ADDENDUM #01

October 29, 2025

TO CONTRACT DOCUMENTS FOR:Project #CP241934 – Memorial Stadium Facilities –
SEZ Recruiting Room Fitout**ADVERTISEMENT DATE:**

CONSULTANT:Simon Oswald Associates, Inc.
2801 Woodard Drive, Suite 103
Columbia, MO 65202
(573) 443-1407

FIELD LEVEL -
RECRUITING -
PLUMBING & FIRE
PROTECTION PLAN

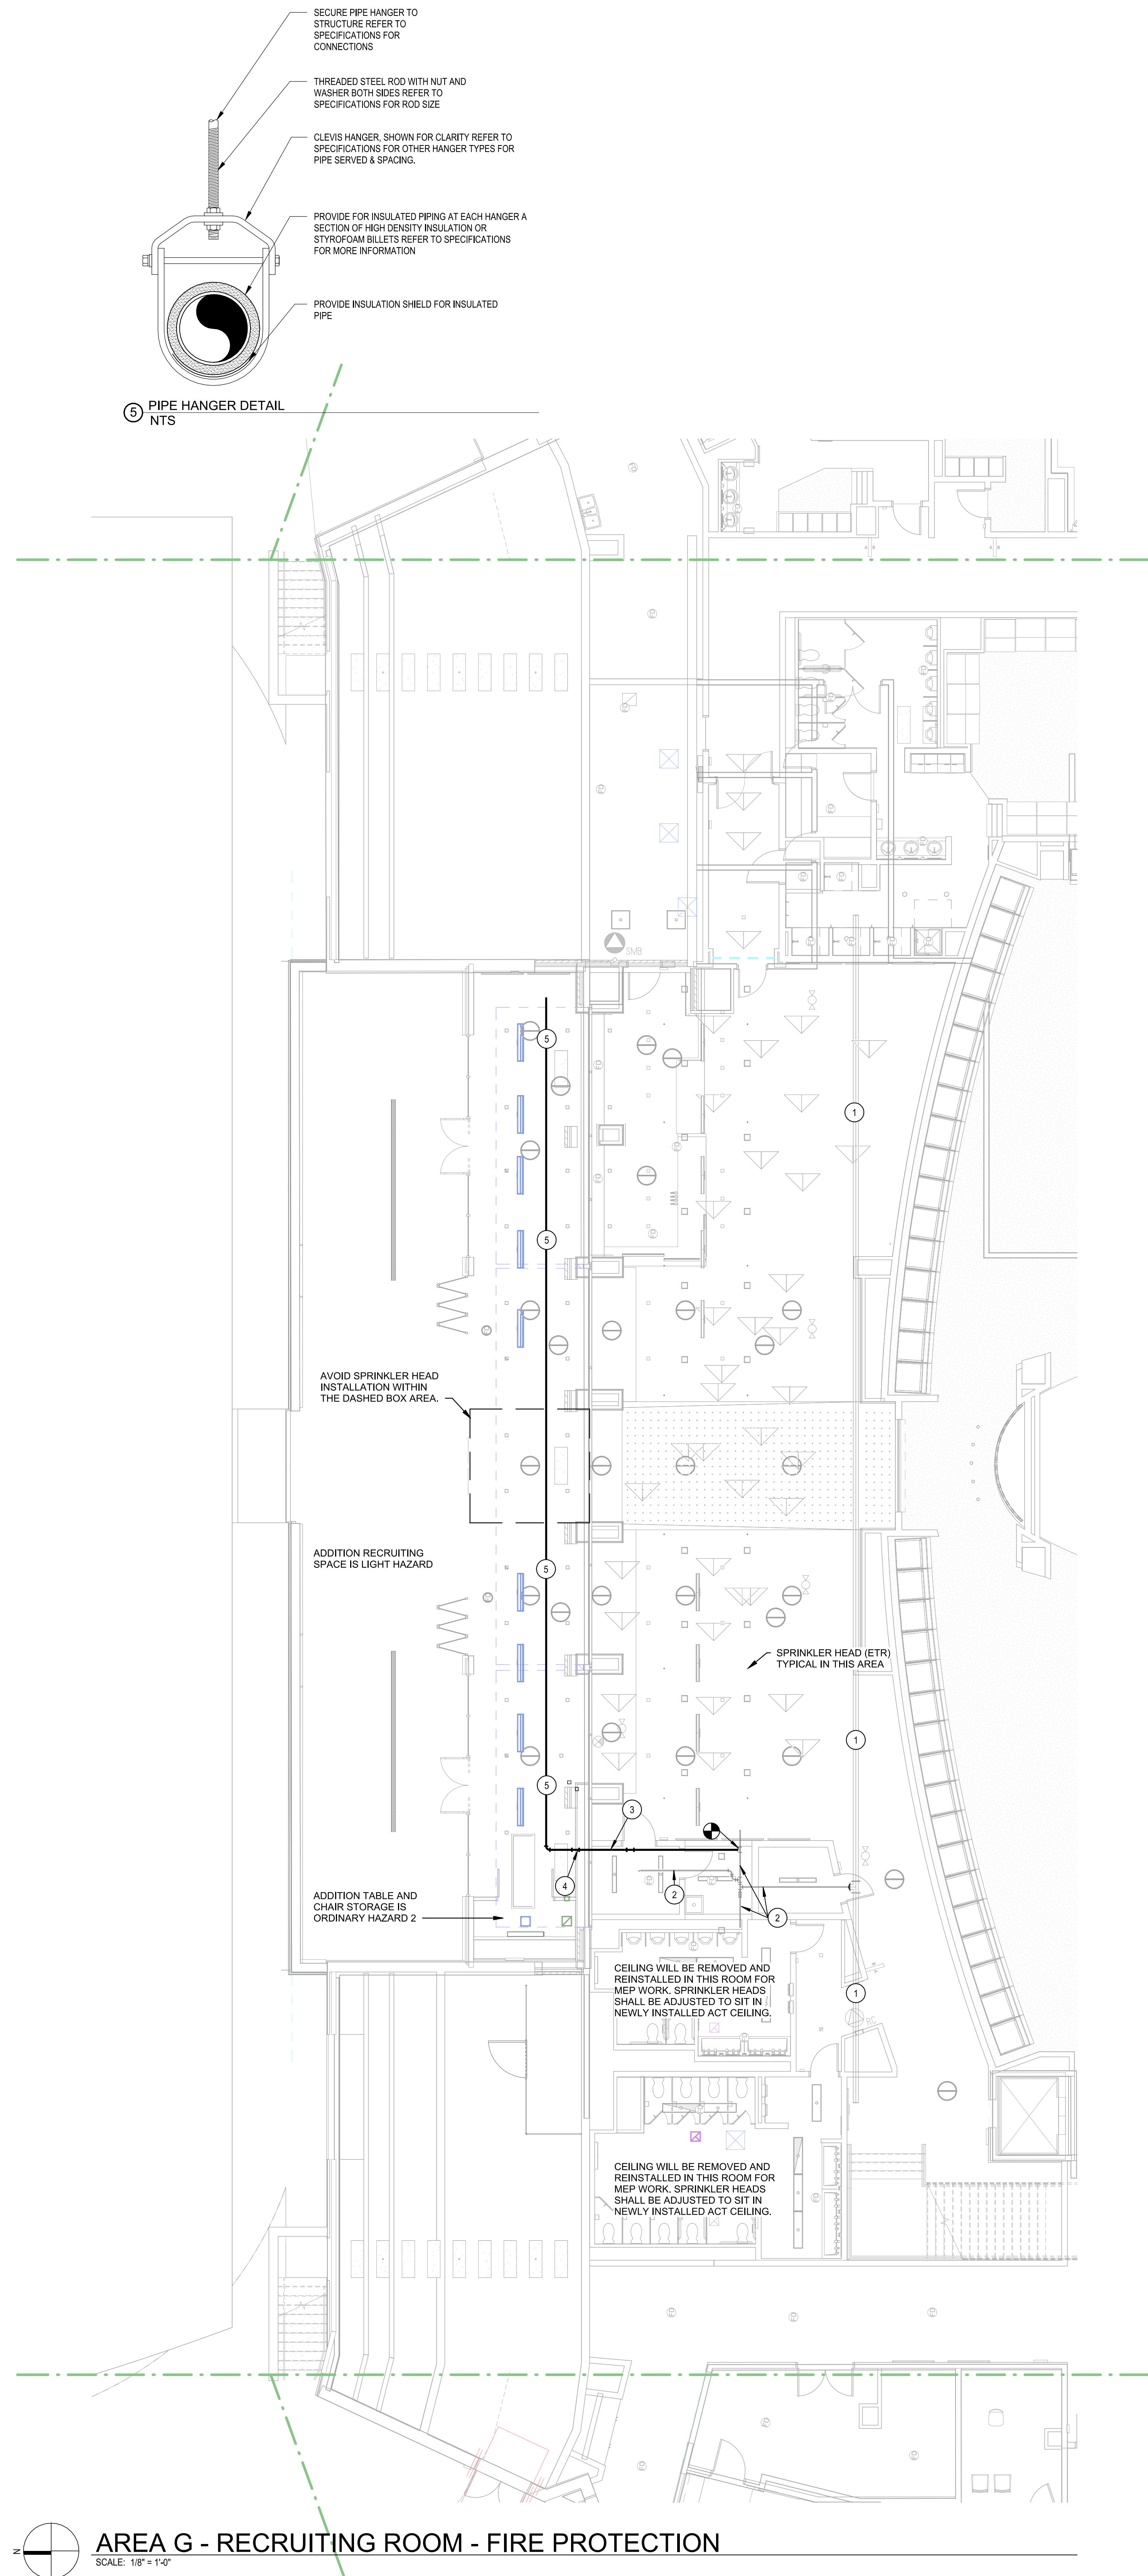
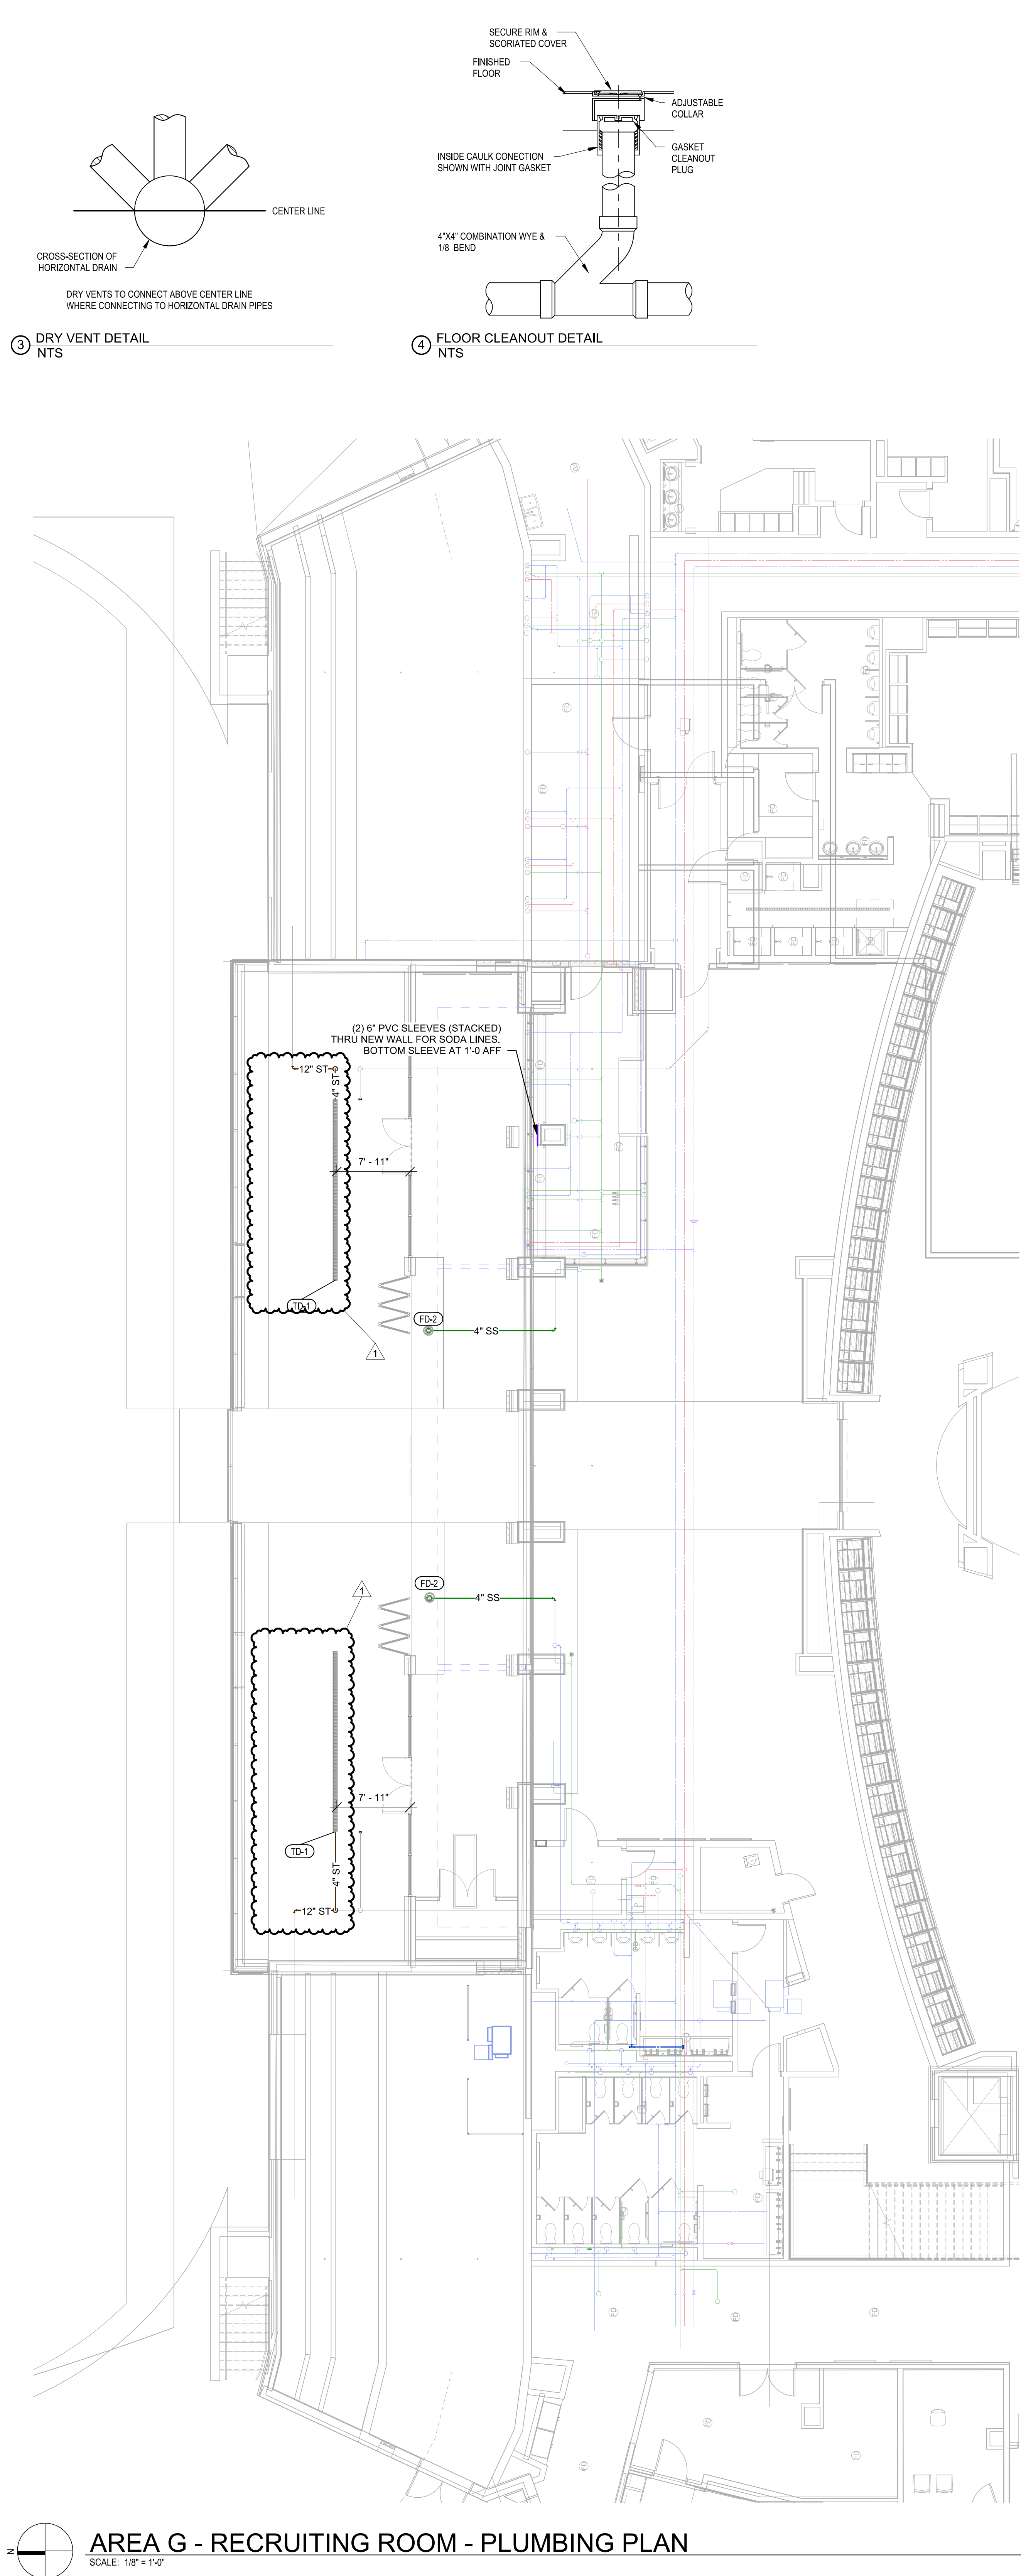
- 11) Drawing sheet P102: **REPLACE** sheet P102 dated 10/02/2025 in its entirety with revised sheet P102 dated 10/29/2025 attached. Revise sheet to clarify the locations of trench drains, TD-1.
